Addendum No. 1
E19: Seguin Road to Nacogdoches Road
SAWS Project No. 15-4506
Solicitation No. CO-00104-DW

**SAN ANTONIO WATER SYSTEM
E19: SEGUIN ROAD TO NACOGDOCHES ROAD
SAWS PROJECT NO. 15-4506
SOLICITATION NO. CO-00104-DW
ADDENDUM NO. 1**

November 11, 2016

The purpose of this addendum is to issue a revision to the Contract Documents, plans and specifications for E19: Seguin Road to Nacogdoches Road (SAWS Job No. 15-4506).

DATE: NOVEMBER 2016	SAWS PROJECT NO. 15-4506	SHEET NO. G5
DESIGN: RWR	FNI PROJECT NO.	
DRAWN: DDH	KMH16157	
CHECKED: DTB

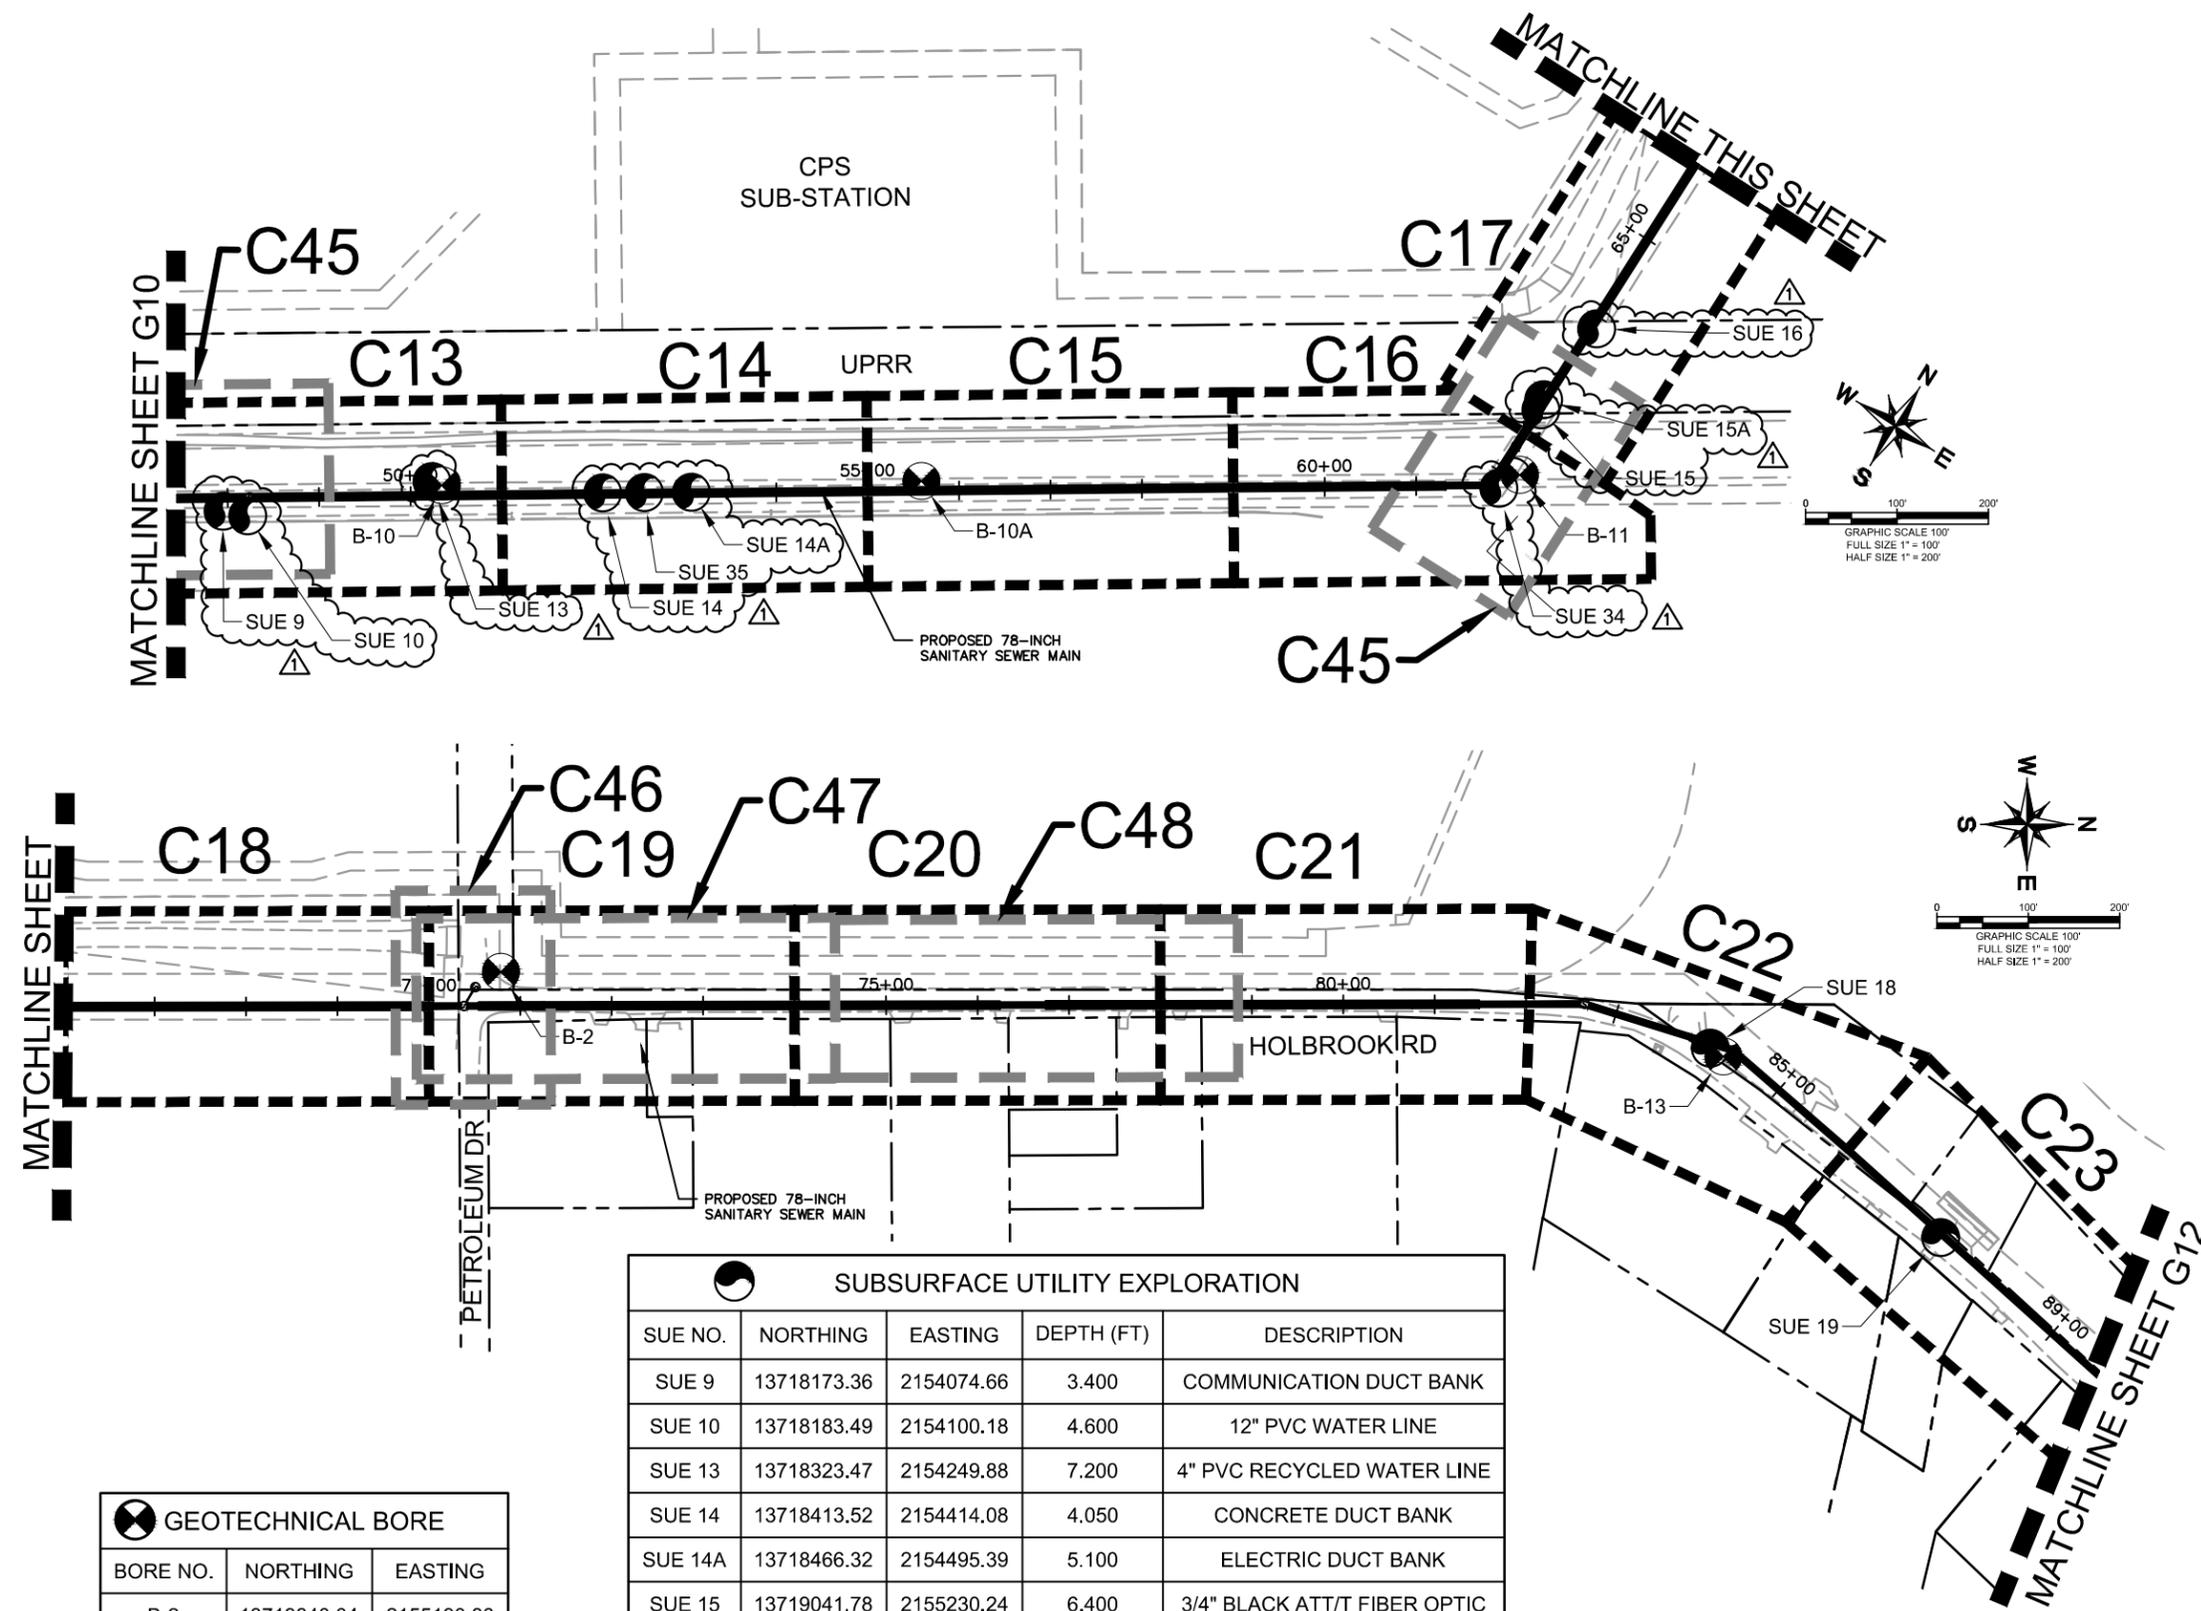
C. REMOVE – Sheet G5 Quantities, REPLACE with revised attached Sheet G5.

SHEET NO. G11

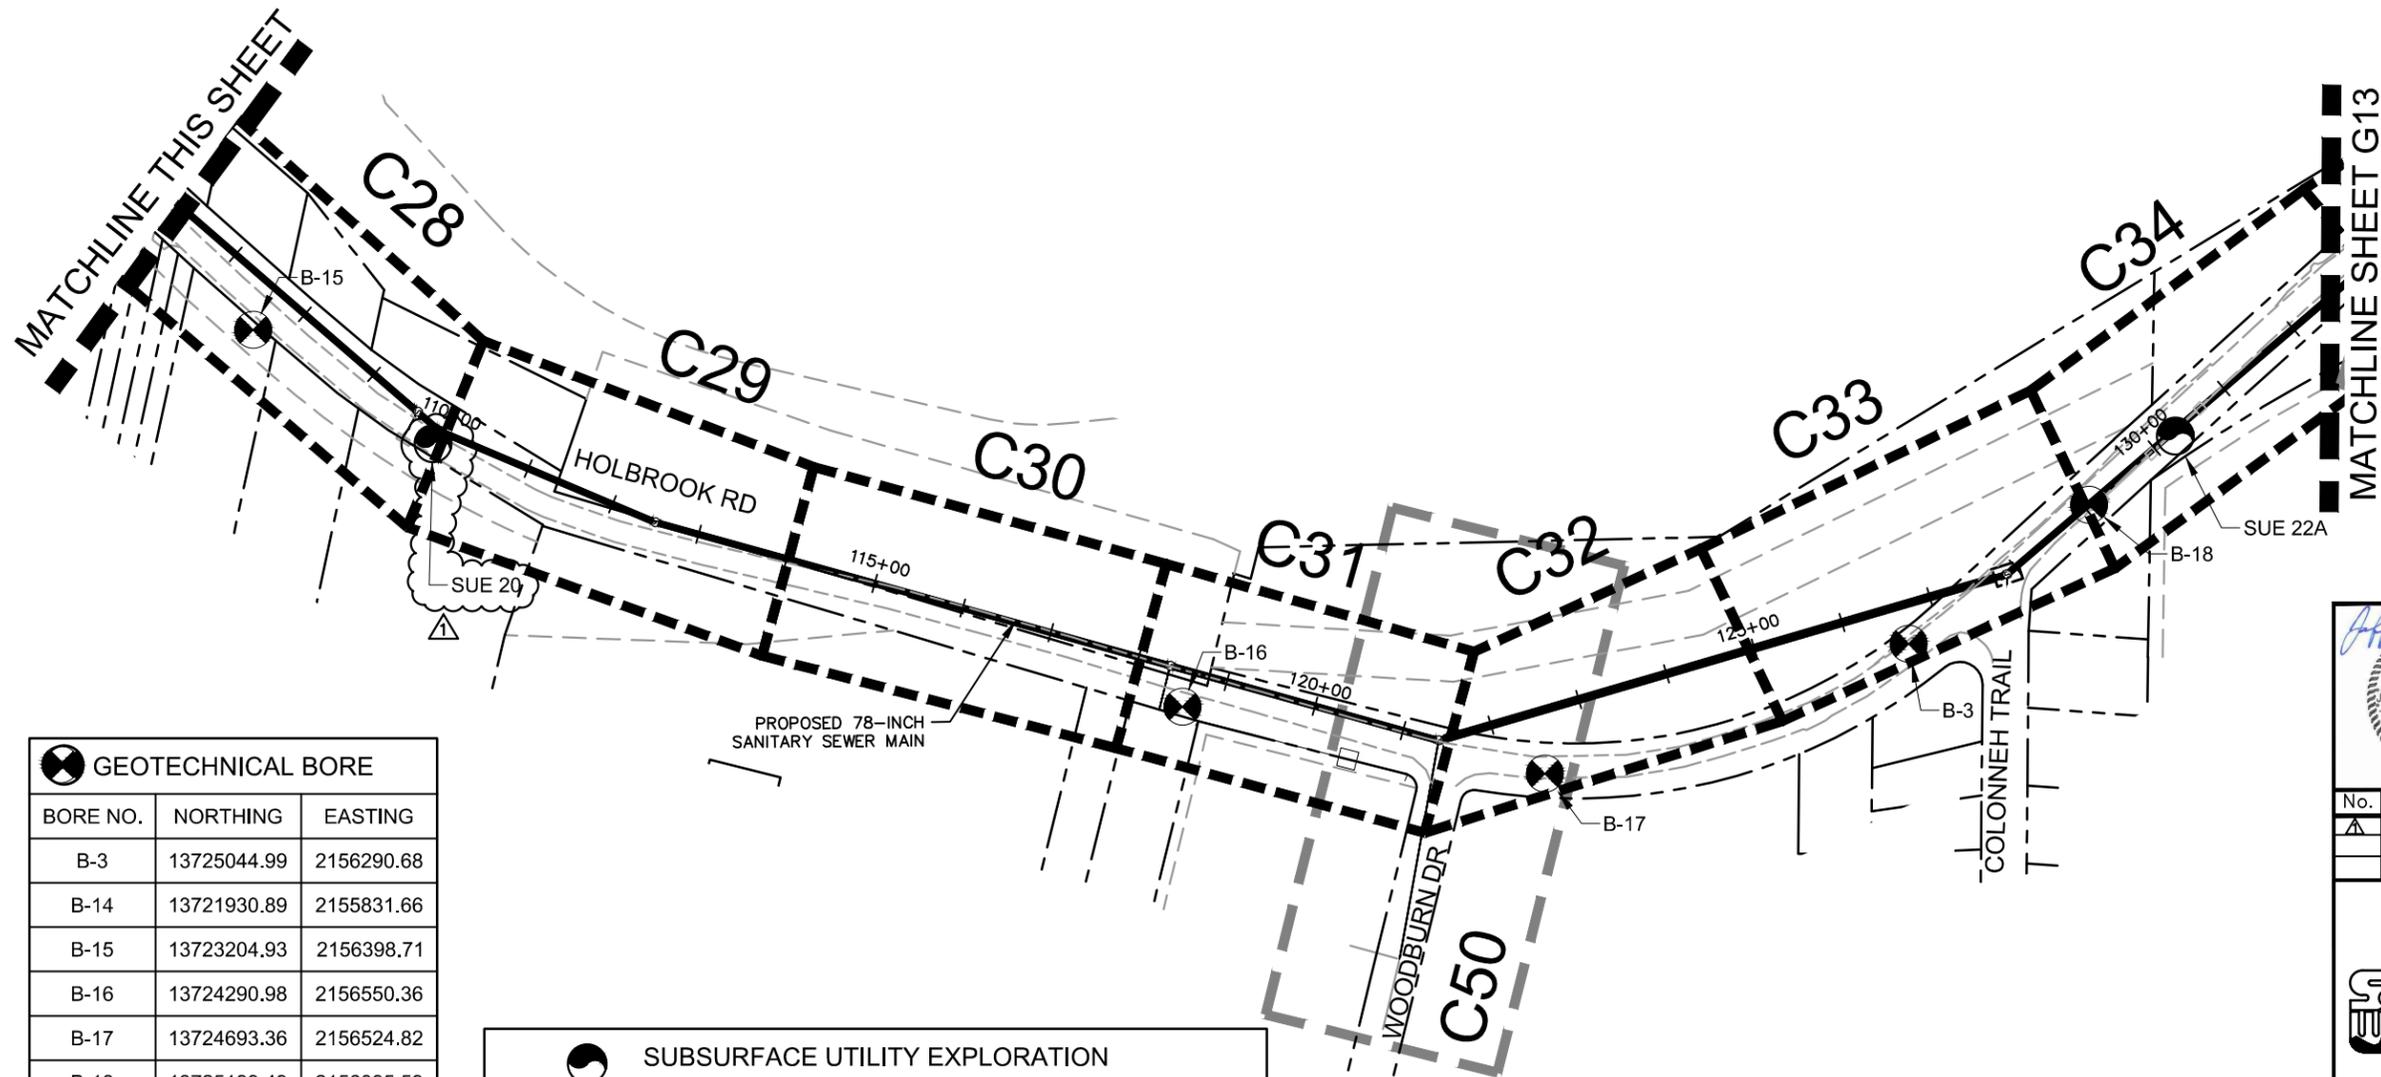
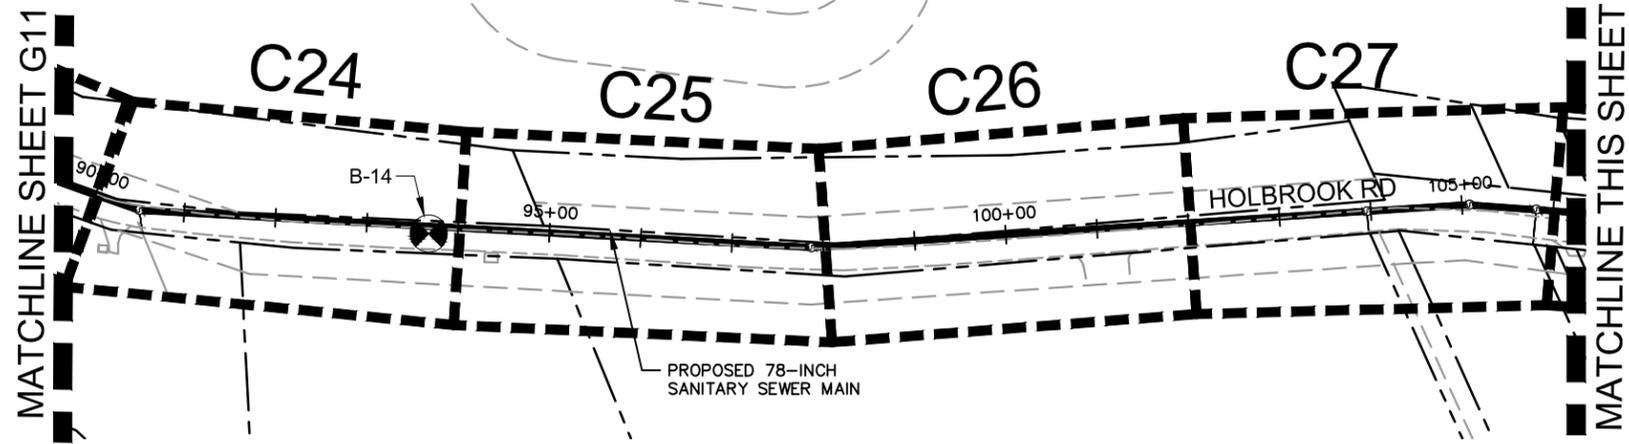
D. REMOVE – Sheets G11-G12 Project Layout (Sheet 2-3 of 4), REPLACE with revised attached Sheets G11-G12
